Swan and Canning Rivers Management Act 2006

DETERMINATION OF DEVELOPMENT APPLICATION

FILE NUMBER : 2021/2616
APPLICANT : The Nature Conservancy Limited
LANDOWNER : Swan River Trust
LAND DESCRIPTION : Swan River (Crown Reserve 48325), within Melville Water – two sites at Freshwater Bay, one site at Point Walter and Attadale (near-to the Swan Estuary Marine Park – Alfred Cove)
DEVELOPMENT : Swan-Canning Shellfish Reef Restoration Project – establishment of shellfish reefs in the lower Swan-Canning Estuary
VALID FORM 1 RECEIVED : 19 October 2021
DETERMINATION : **APPROVAL WITH CONDITIONS**

PROPOSAL	Swan-Canning Shellfish Reef Restoration Project – establishment of shellfish reefs in the lower Swan-Canning Estuary
LOCATION	Swan River (Crown Reserve 48325), within Melville Water – two sites at Freshwater Bay, one site at Point Walter and Attadale (near to the Swan Estuary Marine Park – Alfred Cove)
COST	Estimated \$5 million
APPLICANT	The Nature Conservancy Limited
LANDOWNER	Swan River Trust
LOCAL GOVERNMENT	City of Melville, Shire of Peppermint Grove, Town of Claremont and Town of Mosman Park
MRS CLASSIFICATION	Waterways
DECISION TYPE	Part 5, <i>Swan and Canning Rivers Management Ac

Figure 1. Proposed build areas in relation to pilot reef locations and 7 of the 26 basket survival trial sites.

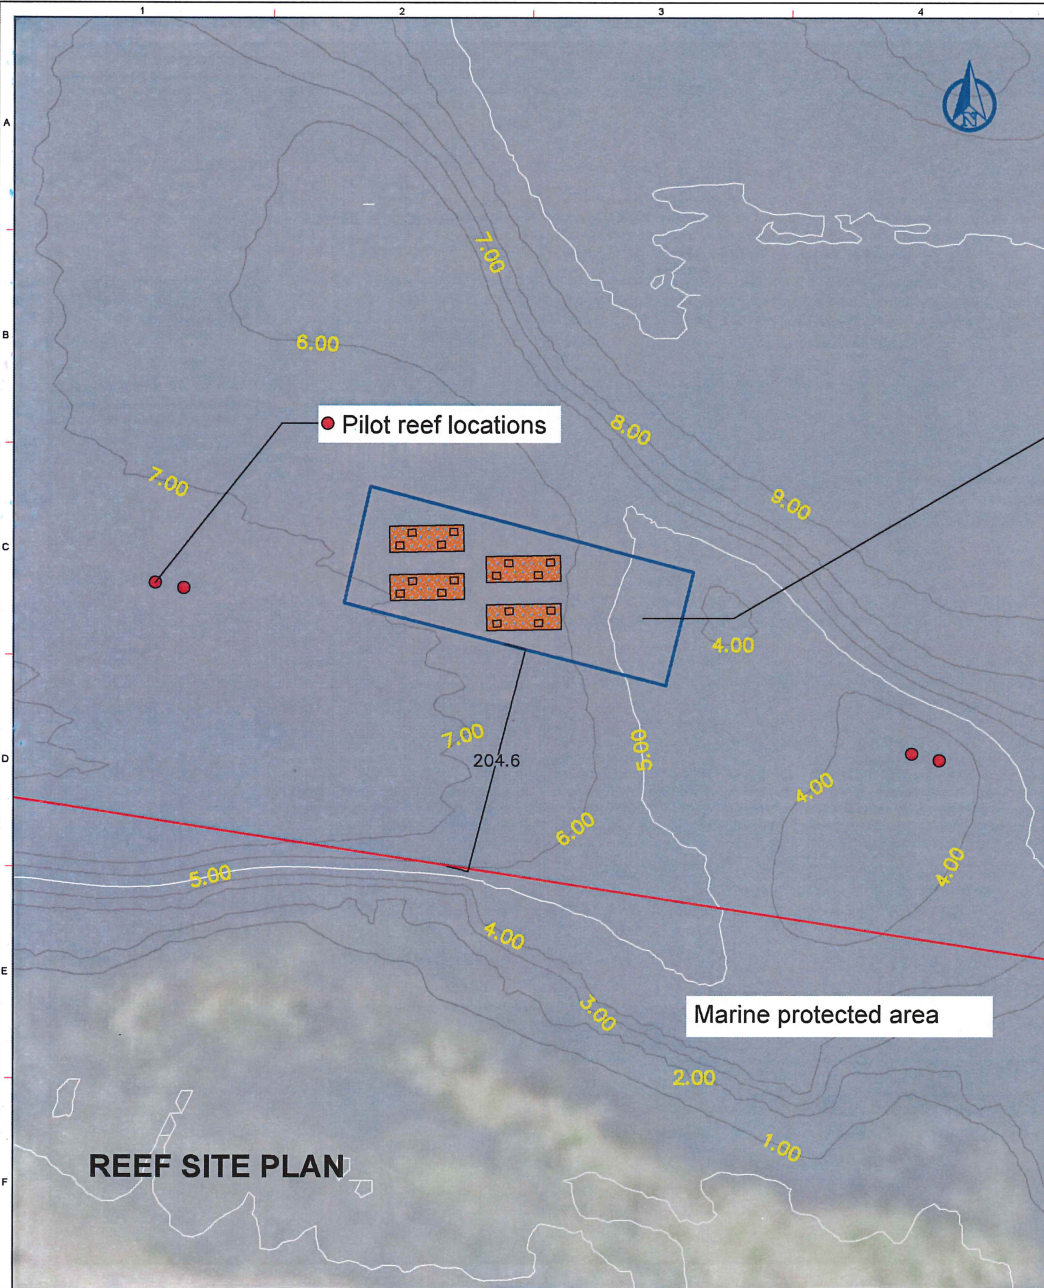
A review of the Aboriginal Heritage Register of Places and Objects, as well as the DPLH Aboriginal Heritage Database, concludes the proposed build areas, as per Figure 1 of the October 2021 Development Application, intersects with registered Aboriginal Site ID 3536 (Swan River). Therefore, approvals under the *Aboriginal Heritage Act 1972* or *Aboriginal Heritage Regulations 1974* will be required.

Attadale Reef site plan

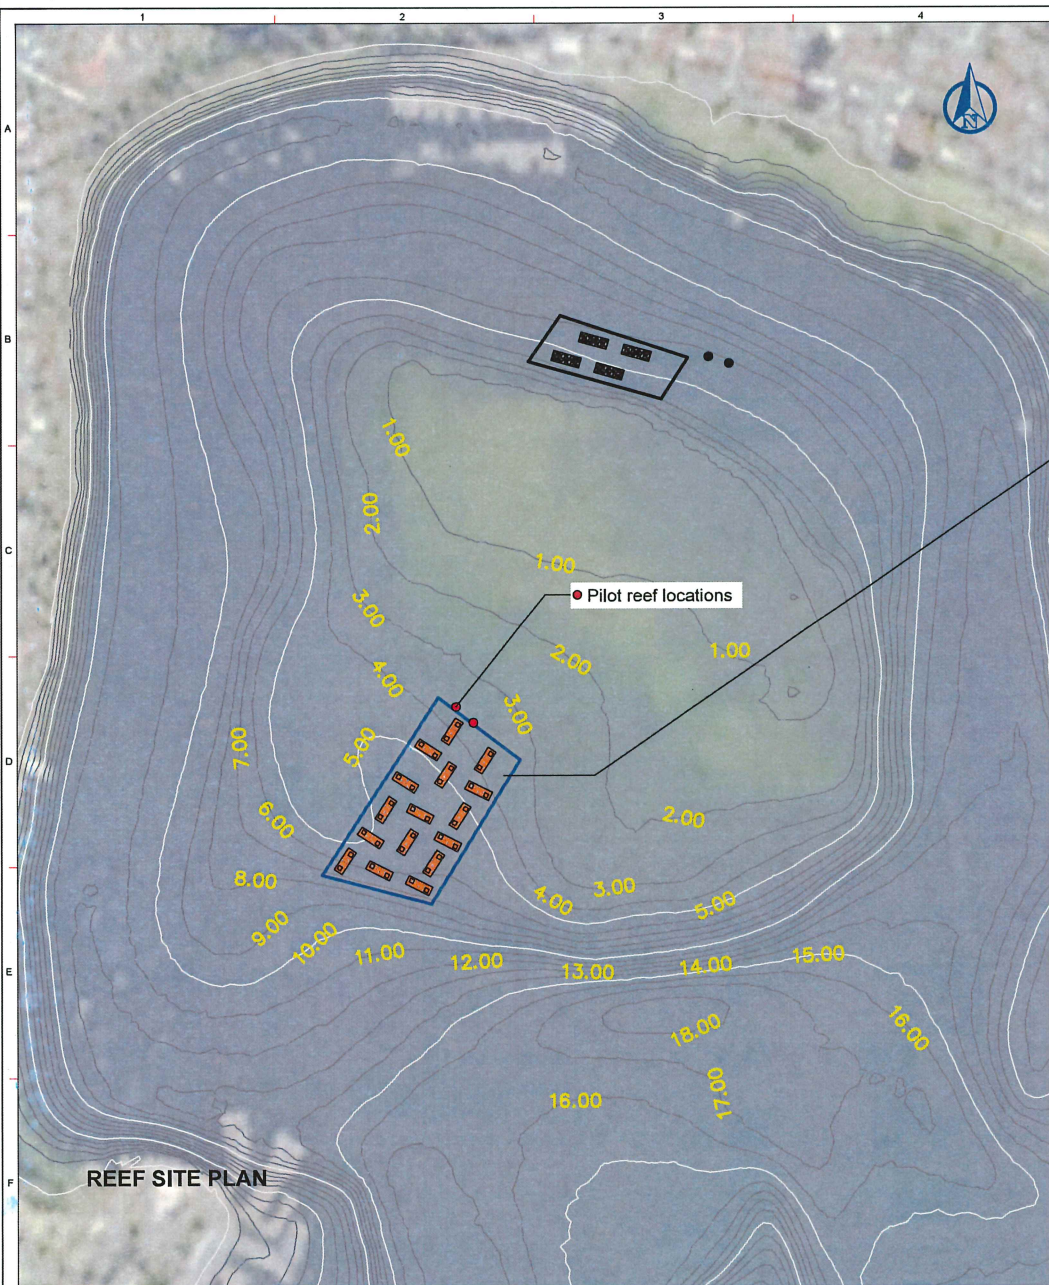
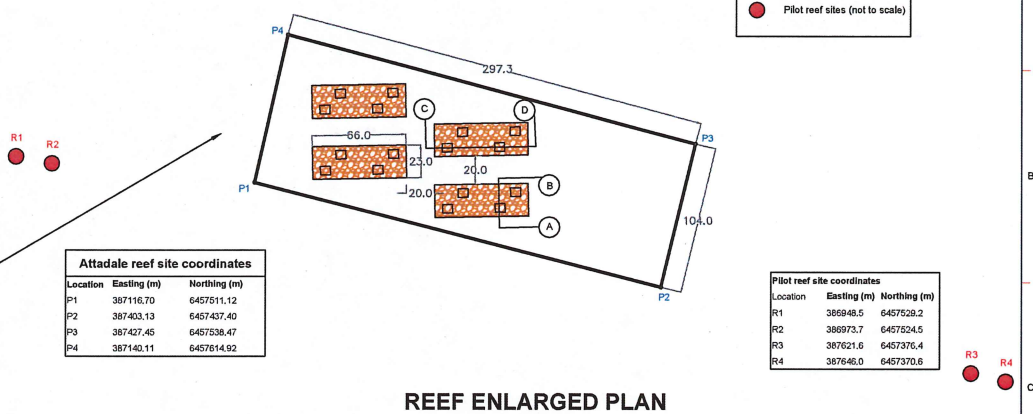
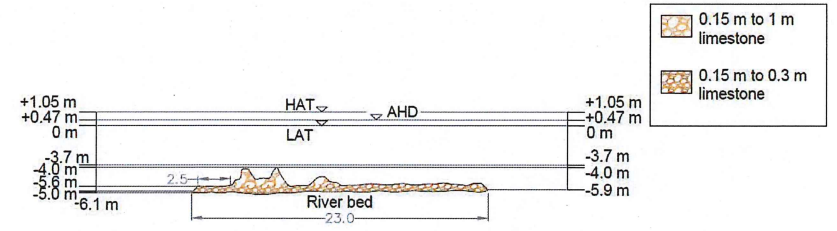
5. All constructed reefs shall maintain minimum vertical separation of four metres at Lowest Astronomical Tide to minimise navigational safety risks.
6. The reefs are to be constructed a minimum of 10 metres from any seagrass beds.

- 1.7. In response to the keel clearance concerns, TNC amended the reef design to increase the vertical separation of the reefs to the water surface from three to four metres at LAT.
